UNITED STATES
NUCLEAR REGULATORY COMMISSION
OFFICE OF INSPECTION AND ENFORCEMENT
WASHINGTON, D.C. 20555

IE Bulletin No. 80-20

FAILURES OF WESTINGHOUSE TYPE W-2 SPRING RETURN TO NEUTRAL CONTROL SWITCHES

FIGURE 1

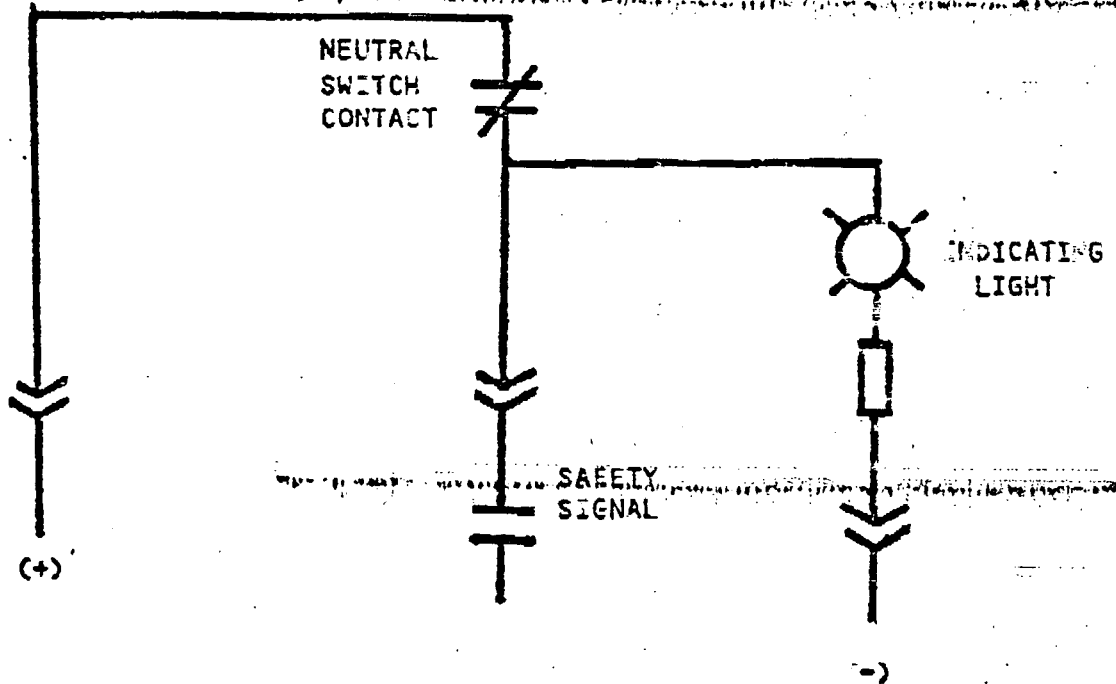
A review of this matter by Westinghouse led to the issuance of NSD Technical Bulletin No. NSD-TB-80-9 to the utility owners of all Westinghouse operating plants. The recommendations contained in the Westinghouse technical bulletin include: (i) testing the neutral position contacts of the subject W-2 switches for continuity, and (ii) rewiring of the indicating light circuit to permit the early detection of a neutral contact failure as shown in Figure 1.

Depending on how the indicating light circuit is wired, loss of continuity thru the neutral position contact of a W-2 switch could remain undetected until the equipment associated with the switch were called upon to operate. Since such a failure would be equivalent to by-passing the system associated with the switch, consideration should be given to rewiring the switches used in safety-related applications as shown in Figure 1. Such rewiring would provide an acceptable means for detecting contact failure, provided the indicating light is in the control room and readily visible by the operator. If the indicating light is not so located, consideration should be given to annunciating the neutral position contact failures at the control room to alert the operator of the inoperable status of a safety-related system. In addition, consideration should be given to adding redundant contacts to the W-2 switches or to replacing the W-2 switches with others having a more positive contact wiping action.

3. Licensees of operating plants and holders of construction permits shall describe the longer term corrective measures planned and the date by which such measures will be implemented by actual installation or by design change, as appropriate. As a minimum, the longer term corrective measures should include rewiring the indicating light as shown in Figure 1 provided the light is readily visible to the control room operator. If not, failures of the neutral position contacts should be annunciated in the control room.

EXISTING INDICATING LIGHT CIRCUIT (TYPICAL)

PROPOSED REWIRING OF INDICATING LIGHT CIRCUIT (TYPICAL)

REWIRING OF INDICATING LIGHT CIRCUIT OF W-2 SWITCHES
AS RECOMMENDED BY WESTINGHOUSE TECHNICAL BULLETIN WSD-TB-80-9
